APPLICATION ON NOTIFICATION – ESSENTIAL INFRASTRUCTURE

RE: The Solar River Project - Proposed Switchyard DA 010/V082/17 V2 - Response to Request for Further Information

**RE: The Solar River Project - Development Number 010/V082/17 – Variation
ElectraNet National Grid Connection 275,000-volt Switchyard – Lot 9, Lower Bright
Road Robertstown, South Australia**

Figure 1 Siting of Proposed Development –

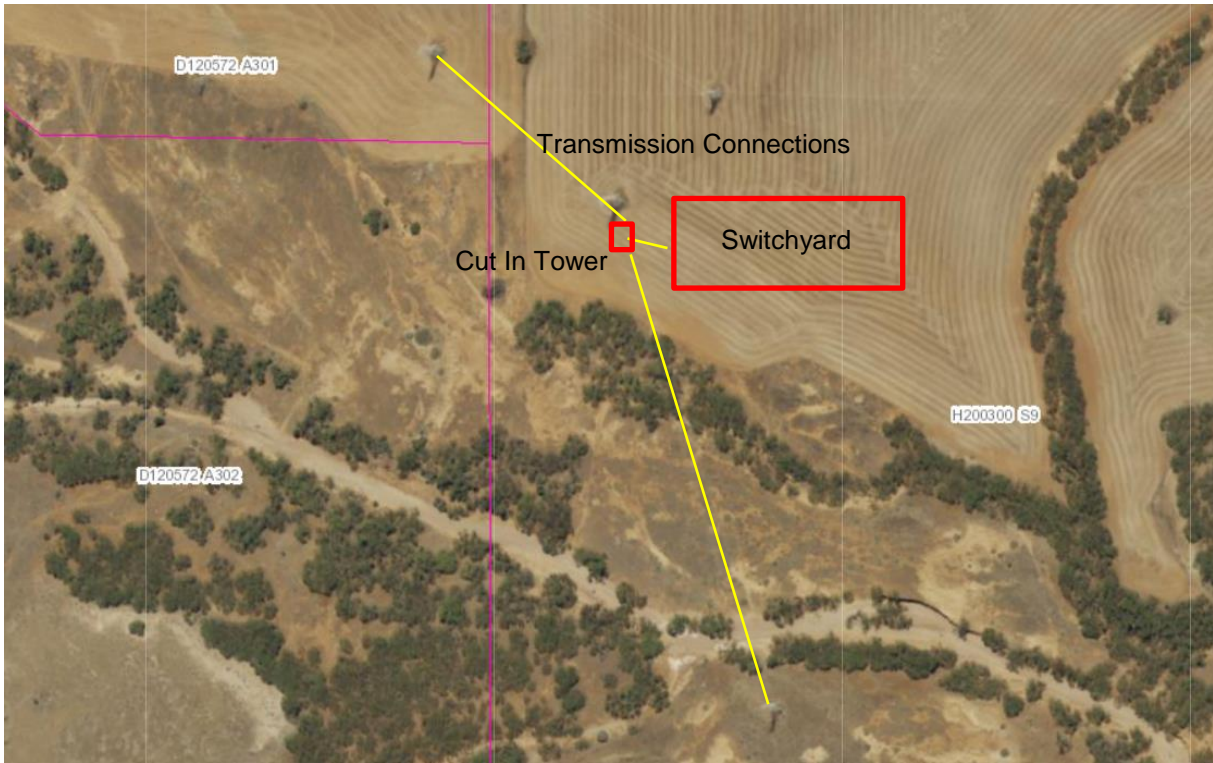
1. *Confirmation required regarding the subject land parcels relevant to this variation, noting that the new Switchyard necessitates an altered route for a portion of the transmission line.*

The proposed development will affect the following parcels of land:

- Section 9 in HP200300, contained with CT 5970/794
- Allotment 301 in DP120572, contained with CT 6230/206

The switchyard (including the proposed access road) will be sited on Section 9. Connection from the proposed switchyard cut-in tower will be provided to the existing 275kV transmission towers located on Section 9 (to the south) and Allotment 301 (to the east).

The proposed siting of the development in relation to allotment boundaries is shown on Figure 1 on the following page.

Fig 1.0

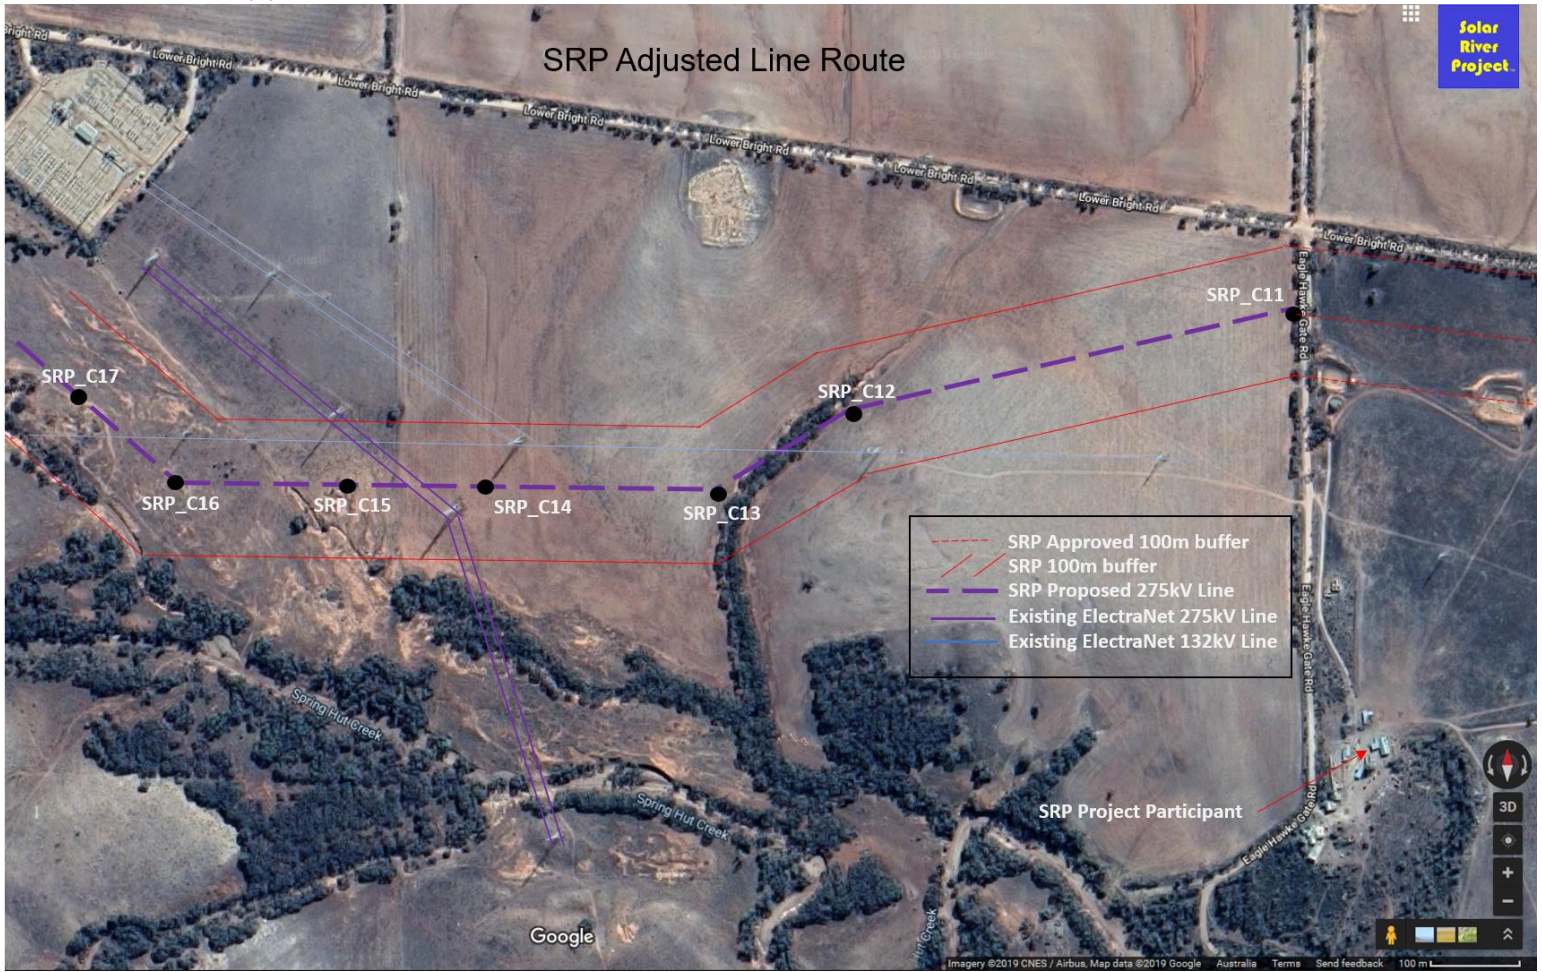
2. The 'DA approved route' and associated 100m buffer as shown in figure 1.0 of the lodgement document is inconsistent with the approved route per 010/V082/17 V1 (refer Stamped Plans – pg 61). Please confirm the intention for this variation to include an amendment to the transmission line route within the above identified allotments, as a result of construction of the switchyard.

Development Application 0101/V082/17 V2 is proposing an amendment to the approved transmission line (as detailed in 010/V082/17 V1).

The transmission line alignment is proposed to be amended, as illustrated in the application documents, to enable connection into and from the proposed switchyard. The variation to the transmission route will be limited to Section 9 and Allotment 301.

PRELIMINARY LAYOUT ROBERTSTOWN EAST SUBSTATION

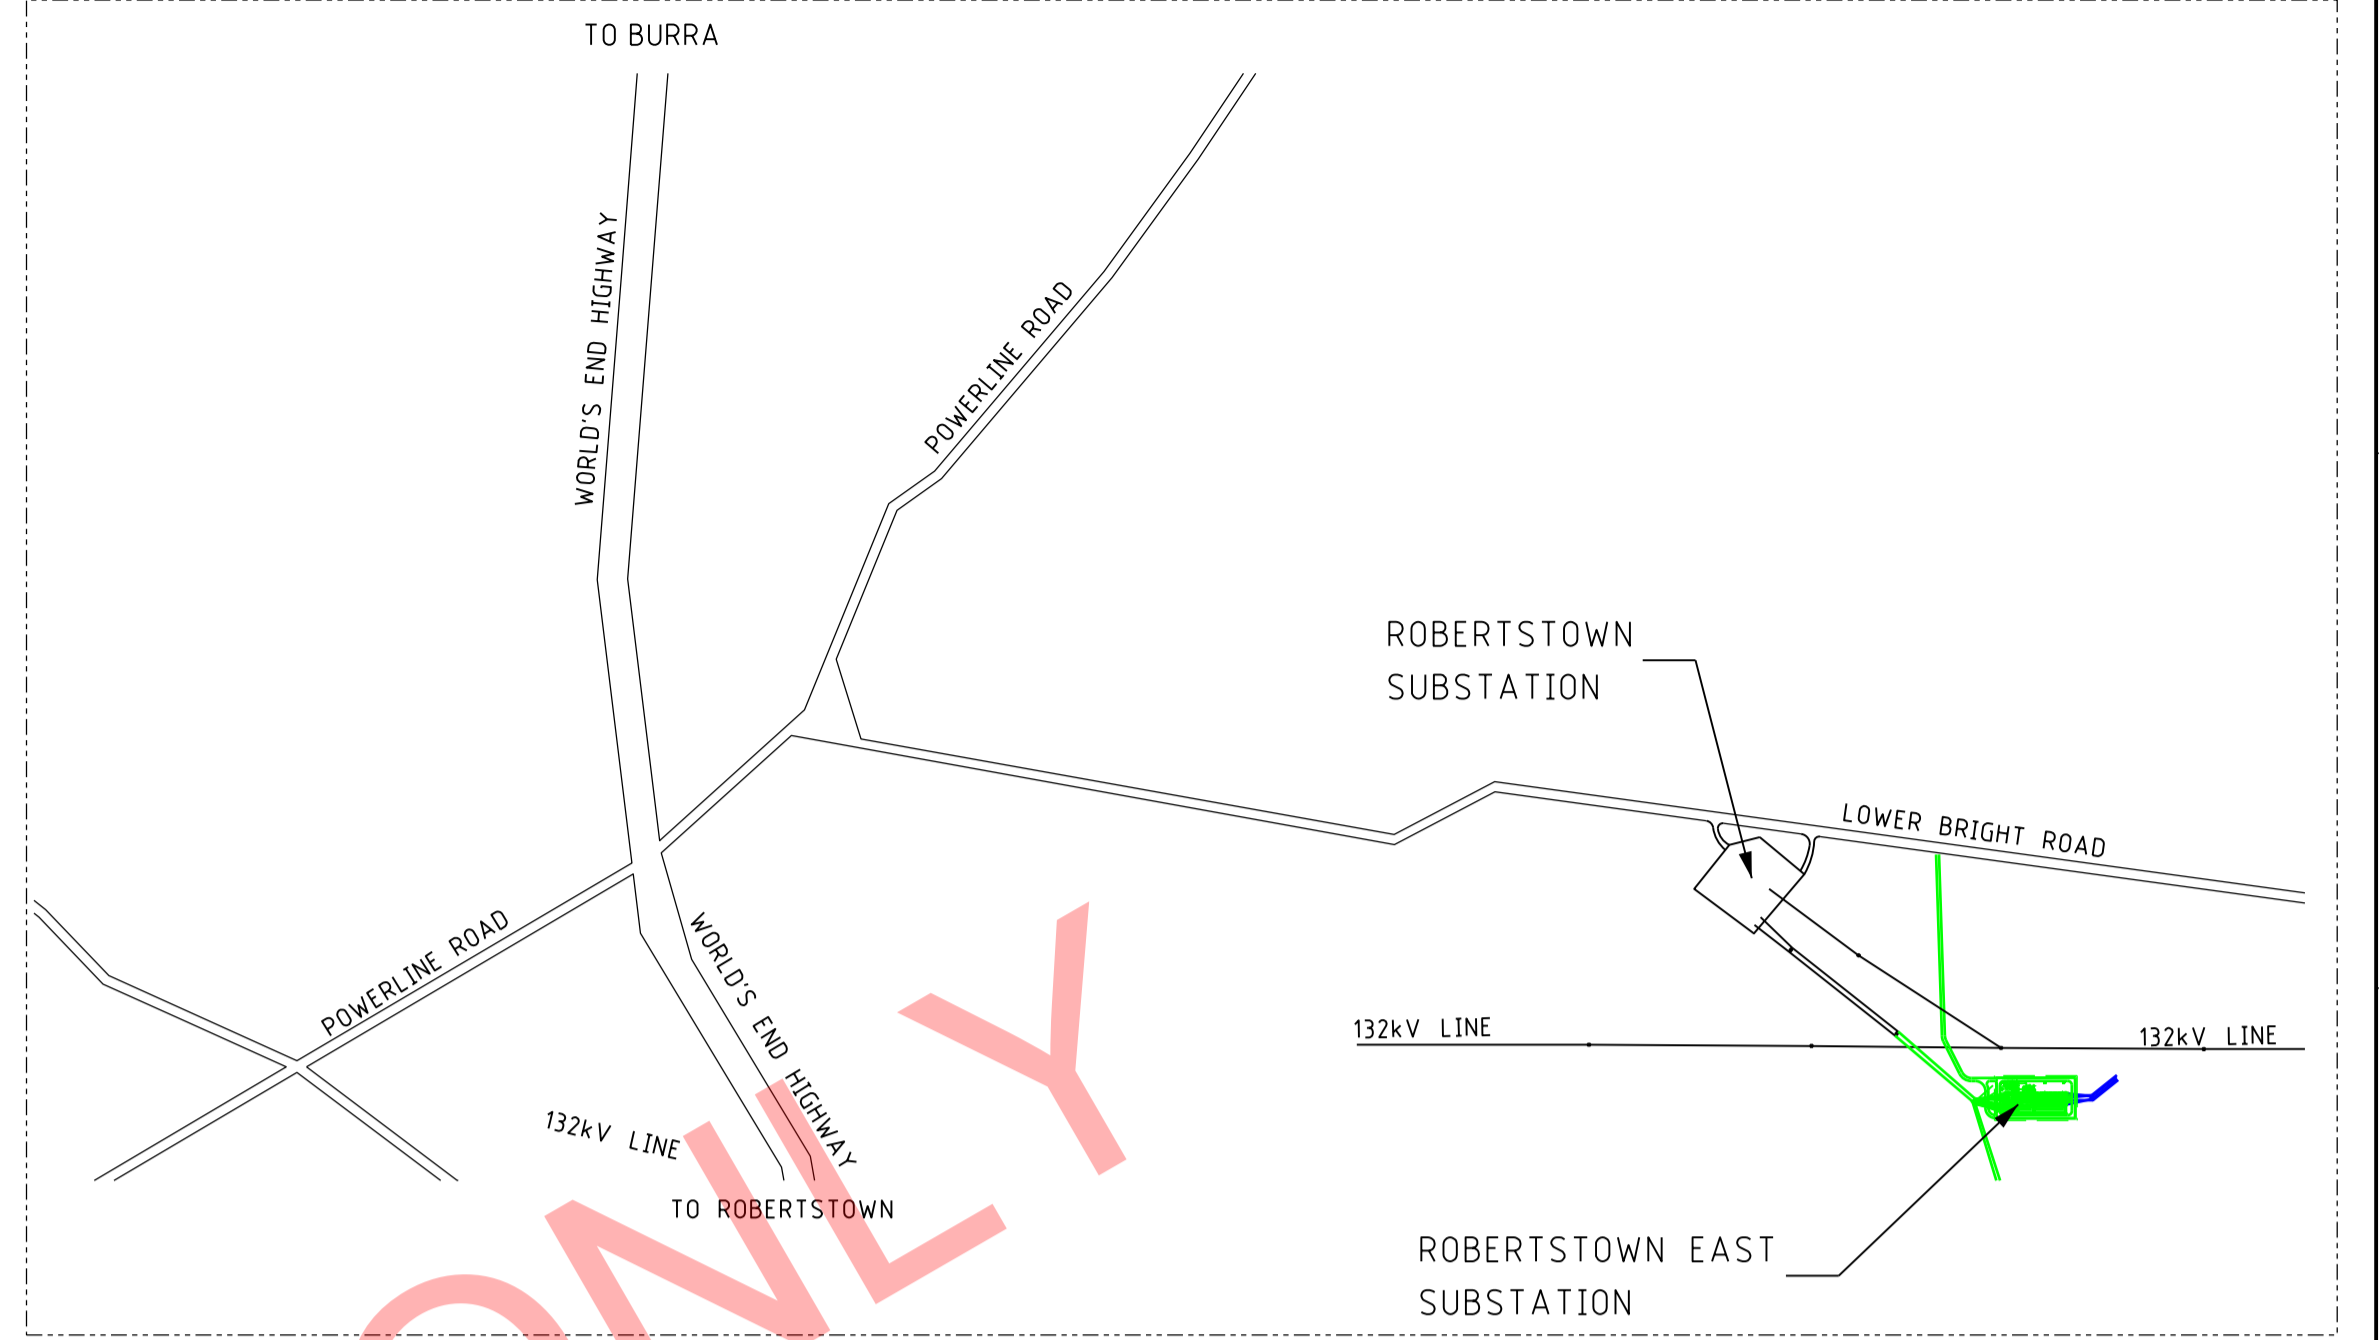
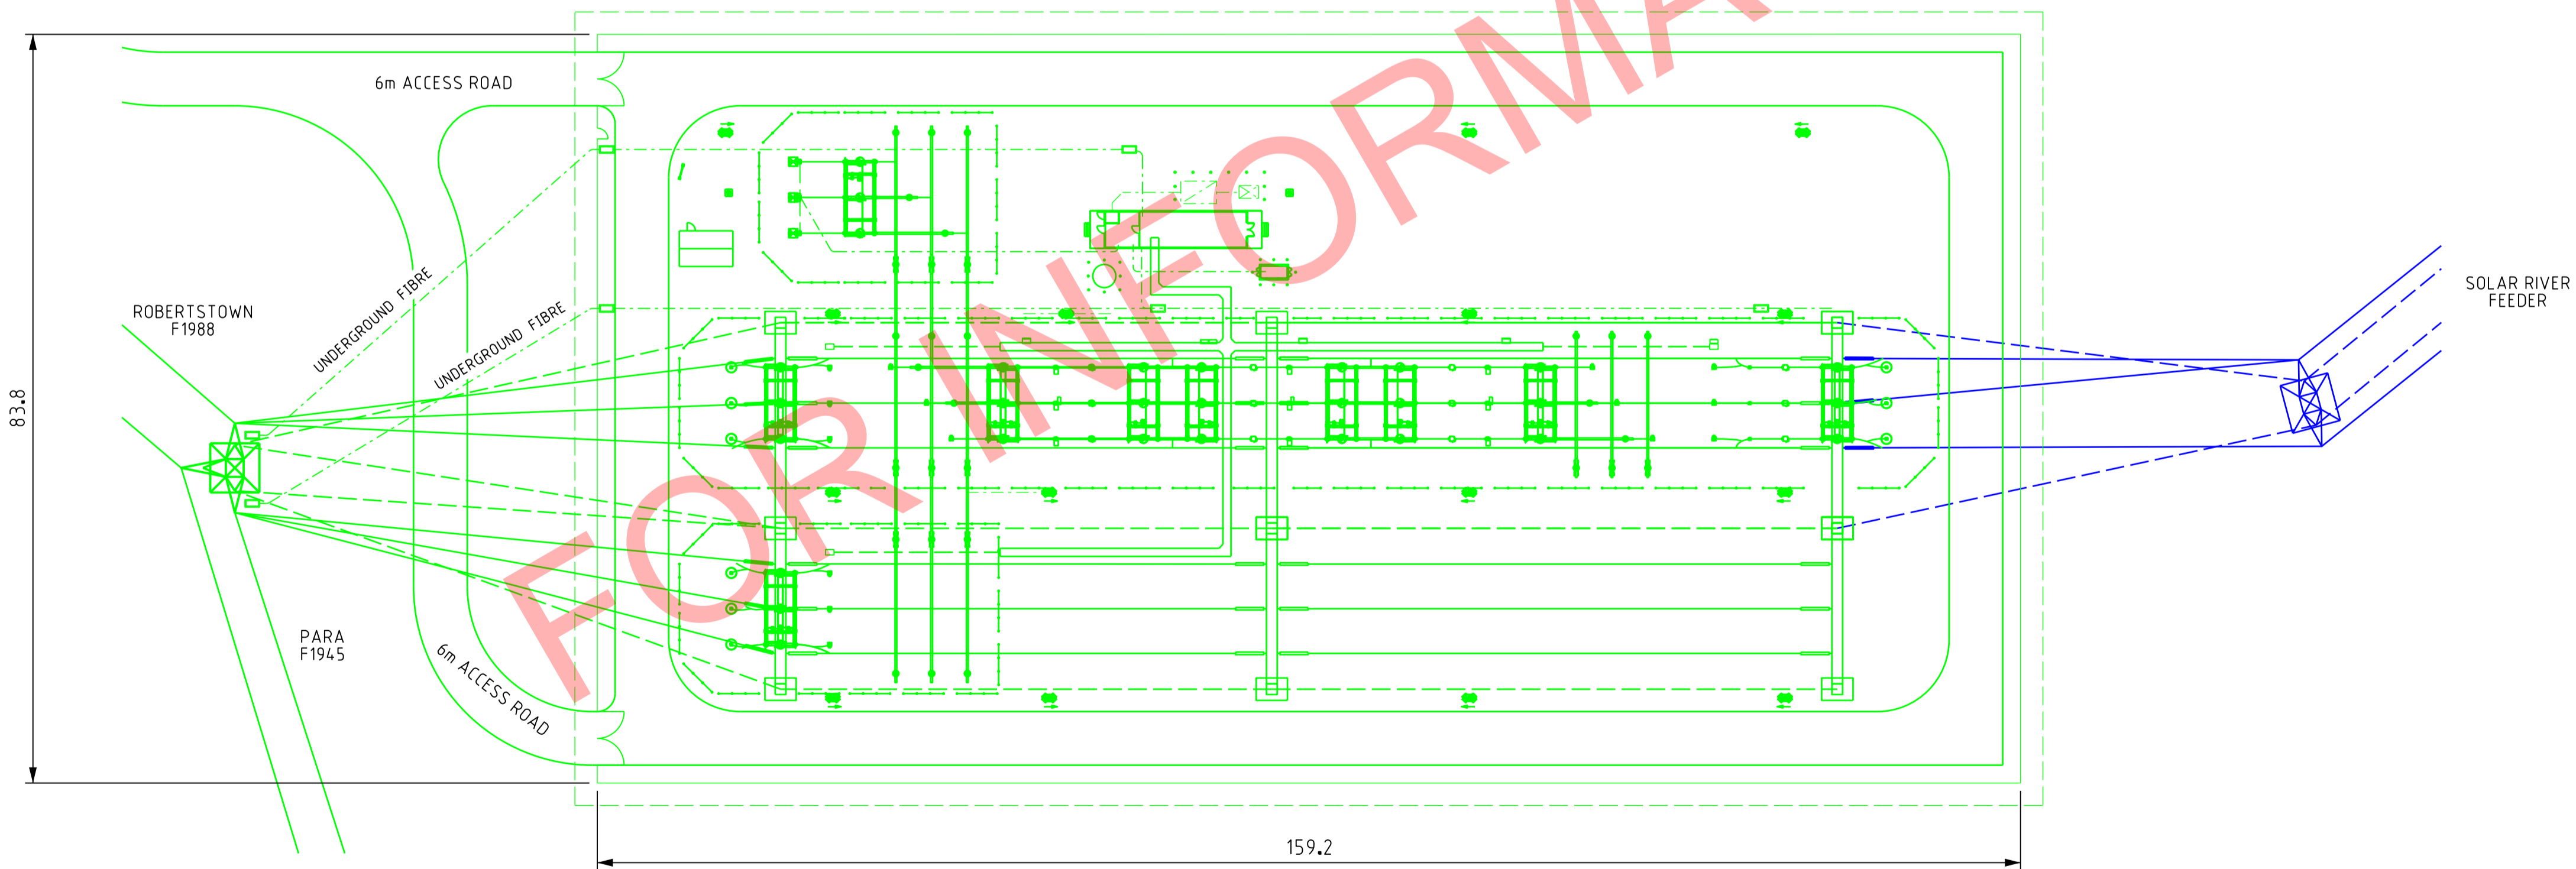
5. *The indicative site plan provided incorrectly labels the facility as a 'Substation'. Temporary laydown areas are not shown.*
6. *The switchyard layout plan provided is poor quality. The 'example connection yard' is not consistent with the layout plan/site plan.*
7. *The elevations provided are of poor quality, illegible and not to scale. The elevations do not indicate the level of cut and fill required for the development.*
8. *The proposed fencing details are provided in writing only – scaled concept drawings with dimensions should be provided.*

In response to the above items, updated and additional plans have been prepared and are provided in Attachment B.

- Site Plans
- Elevations for the proposed switchyard (including fill detail) and cut-in tower
- Fencing details and elevations
